**Replacement Instructions for the Bolts
on the Meridian Ejector Pillow Blocks**

Date: February 24, 2017
Bulletin Name: FEL-TSB-031-A
Model: Meridian Front Loader 78
Model Year: 2016

Figure 5

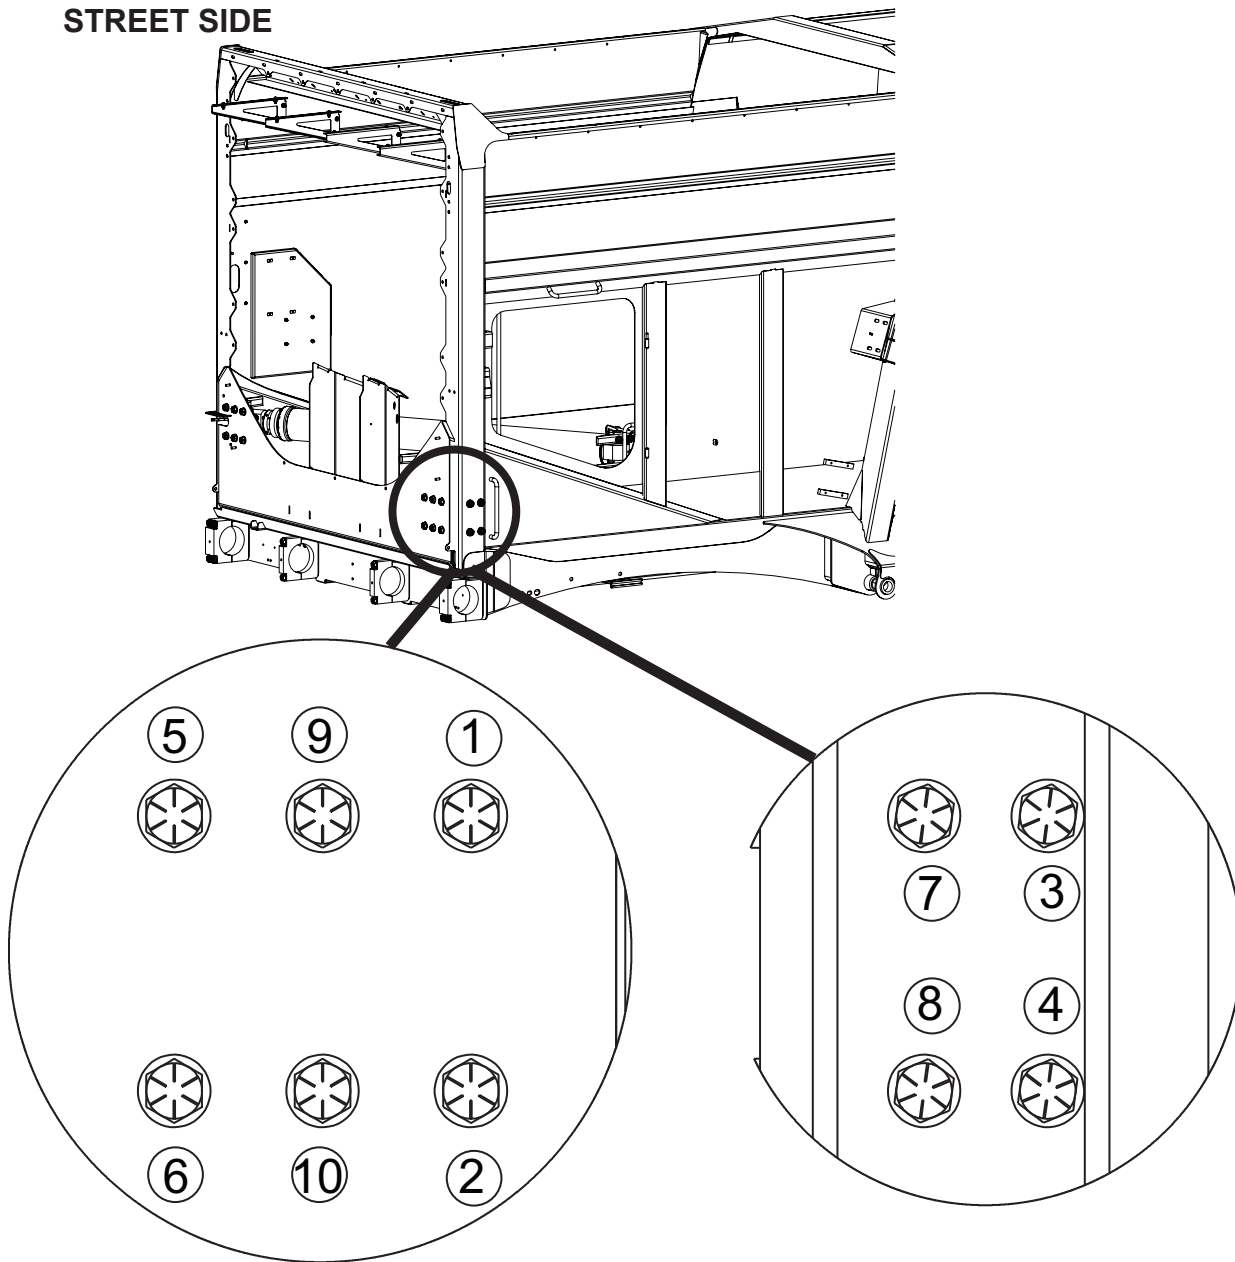
8. Working on one bolt at a time starting with bolt #1 in Figure 5 which illustrates the street side bolts or Figure 7 for curb side bolts, use a hand-held propane torch to heat the head of the bolt and wait approximately 60 seconds. **WARNING!** Heated metal may burn. Be extremely careful of hot metal. Use proper personal protection equipment when handling heated metal.

16. Repeat Steps 8-15 to each of the remaining bolts following the sequence in Figure 5 for street side (or Figure 7 for curb side), one bolt at a time.

15. Use a torque wrench to torque the bolt to 400 ft.-lbs.

Figure 6

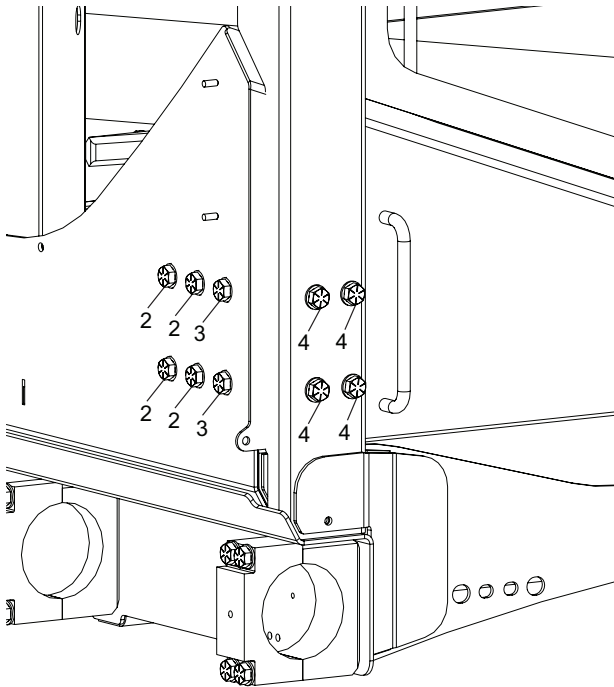
13. Apply Loctite 263 to the correct new bolt (see Figure 6 below for street side or Figure 8 for curb side for parts list of bolts).

14. Install the new bolt and a new washer (P/N 0120282).

Figure 7

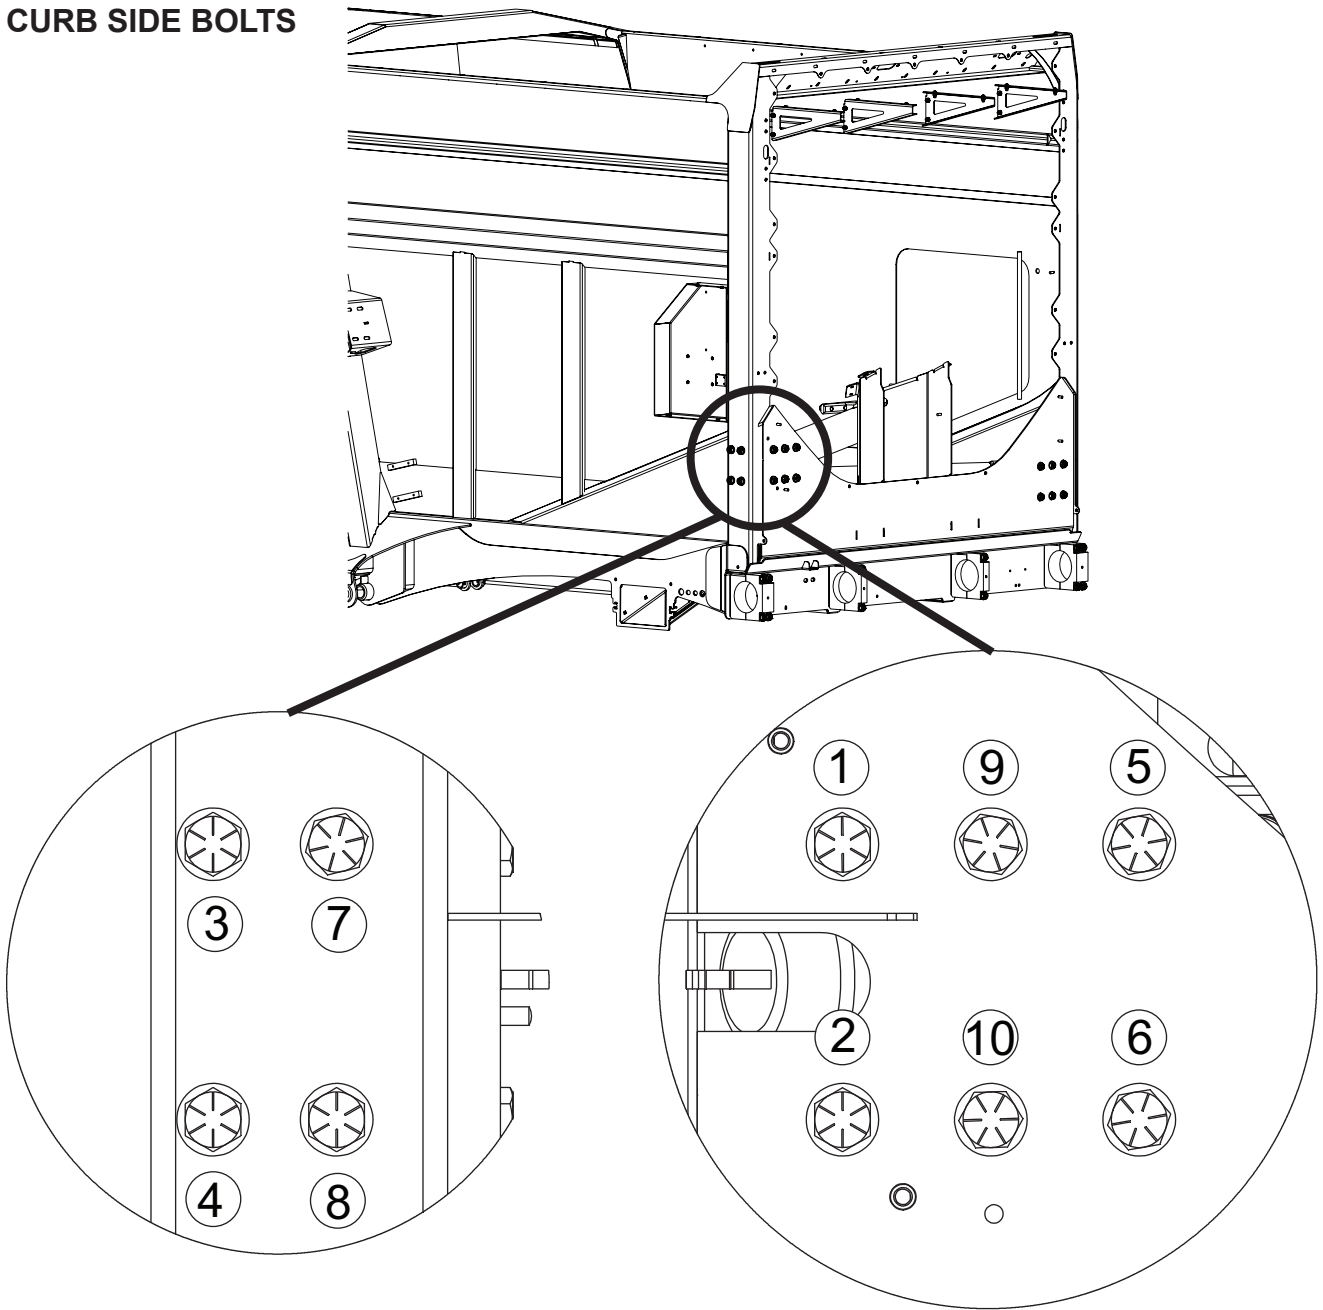
19. Move to the **curb side of the vehicle** and conduct Steps 8-16 for the curb side ejector pillow block bolts. See Figures 7 and 8 for curb side illustrations.

Figure 9

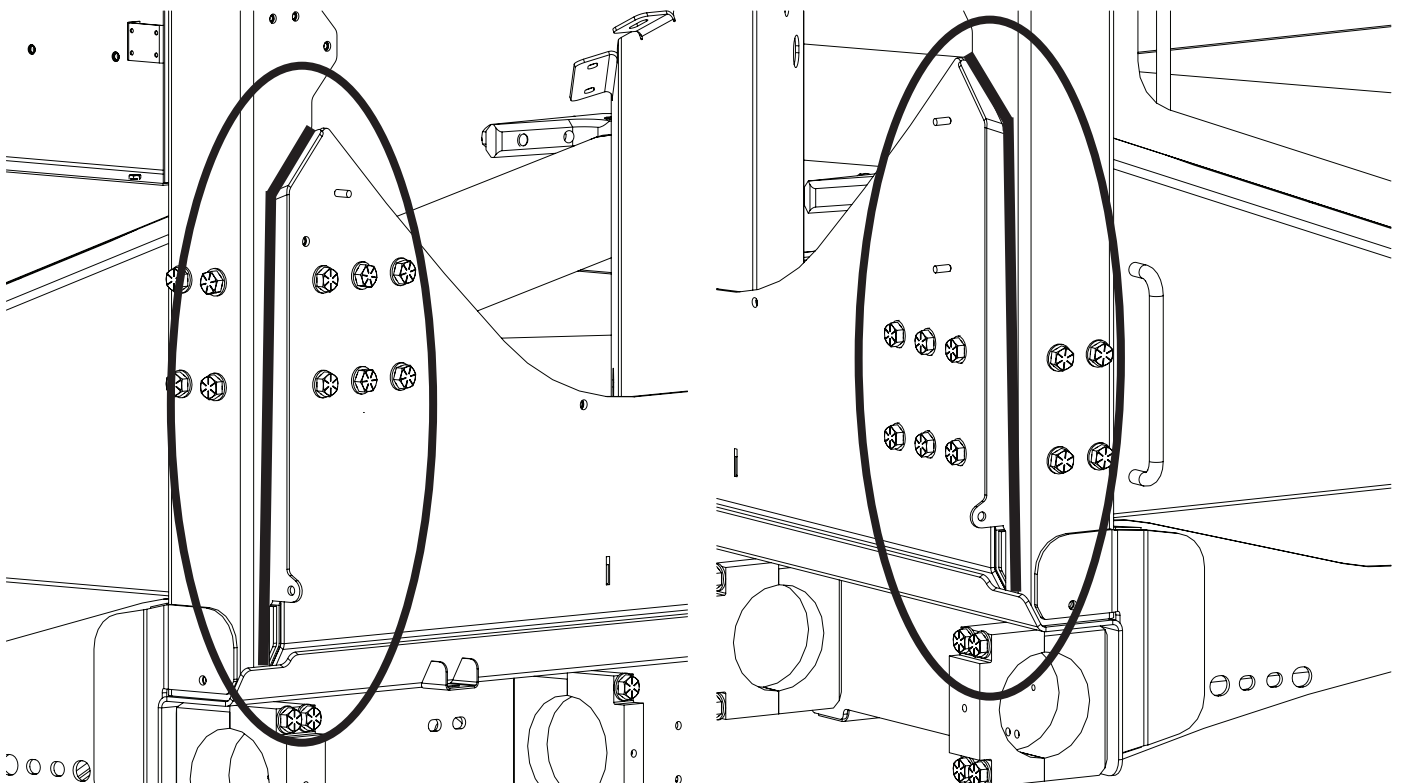
20. When all of the ejector bolts have been replaced and torqued on both sides of the vehicle, inspect the head frame post weld on each side of the vehicle for cracking (Figure 9). If cracked weld is found on either or both sides, contact McNeilus National Service at 888-686-7278 for more information.
